ADDENDUM No. 2

Invitation to Quote PS-24-05 COMMUNICATION TOWER INSPECTIONS

This addendum is being provided in clarification to ITQ PS-24-05 released May 28, 2024.

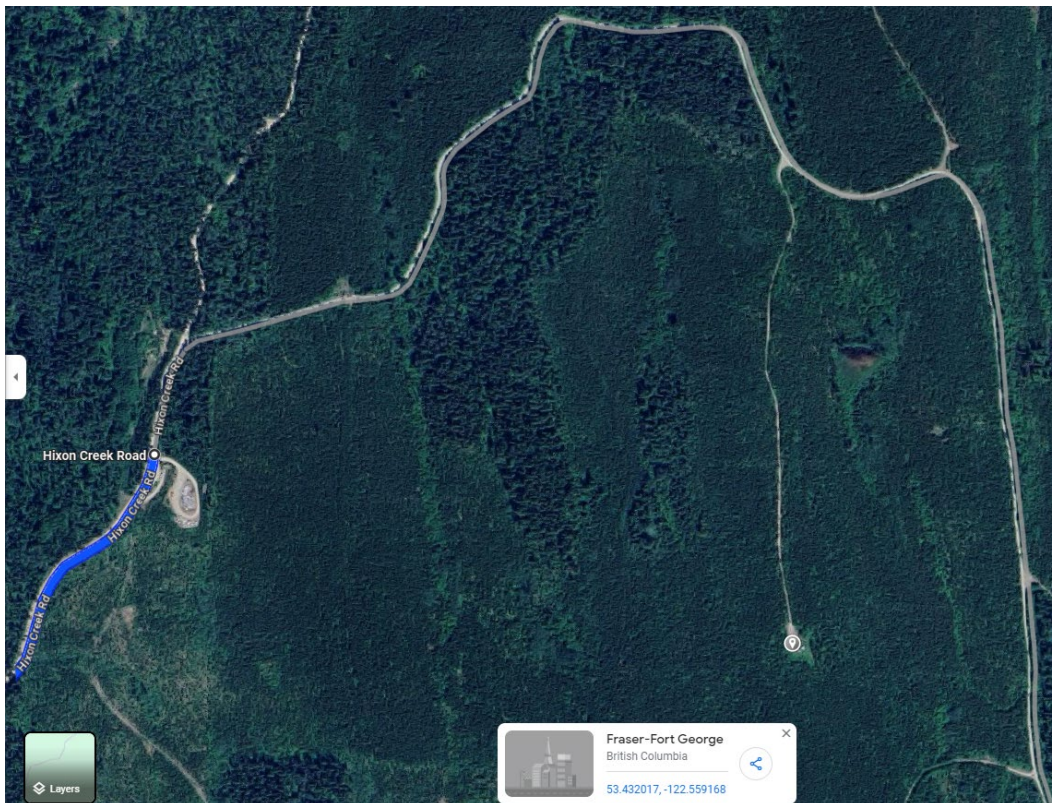
Question 11: Is it possible to confirm the coordinates for the Hixon Overlook Tower? The address given is the road address for the Hixon Regional Transfer Station, and I don't actually see a tower anywhere on the satellite view at that address – 505 Hixon Creek Road.

I think it might actually be at this spot: 53.432184, -122.559120

If this is the case, do you if that road is truck + towable trailer worthy?

In my backroad BC experience, some of the logging roads are not so well maintained.

Answer 11: The Regional District apologizes for the incorrect address. The updated GPS coordinates are 53.432184, -122.559120. All roads are in decent shape and there should be no issue with towing a trailer into the site.
